# O'CONNELL ST PRIMARY SCHOOL PARRAMATTA

EXTENSION TO EXISTING ROOF  
PLANT PLATFORM

RESPONSE TO OEH

FOR THE DEPARTMENT OF EDUCATION  
& COMMUNITIES

Figure10: North Elevation showing the Proposed location for the extension of the Plant Platform.

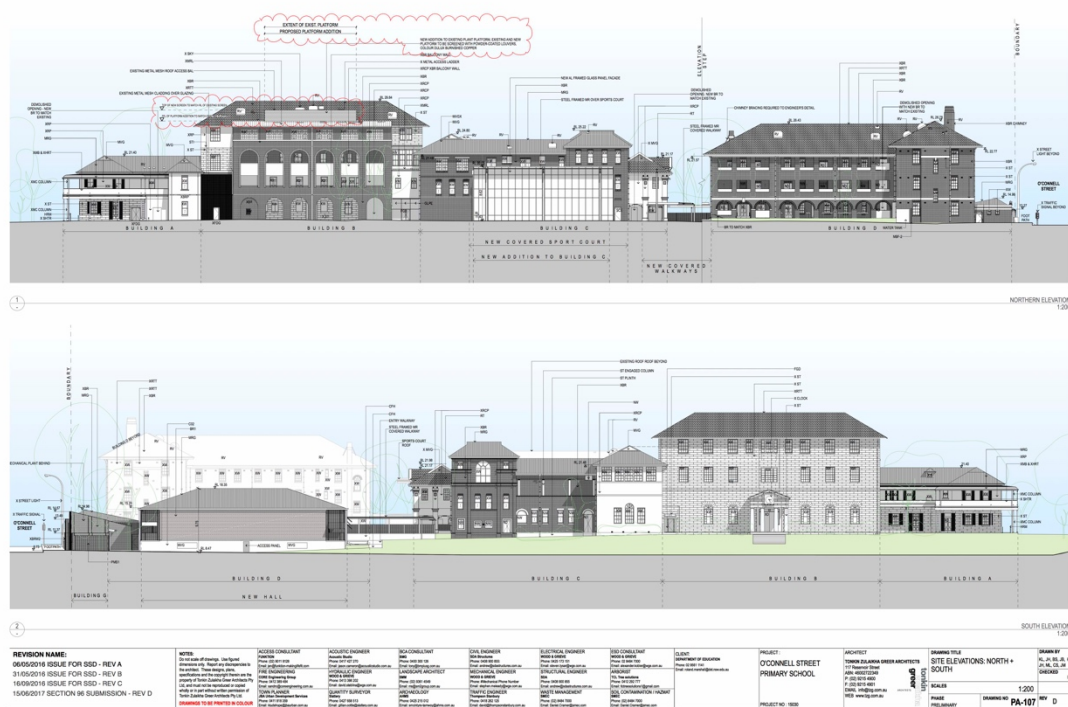
The extension to the plant platform is necessary to accommodate the new condensor units required to serve Buildings A, B and C of the new O'Connell Street Primary School. The extended platform has been detailed to match the existing and to provide improved safe roof access via the existing roof hatch. Powder-coated louvres are proposed to surround the platform to screen the condensers and reduce their visual impact compared to the existing which are light coloured and fully exposed. The height of the platform and units falls well below the existing main ridge level, and will not be visible from the river frontage, which is of primary significance.
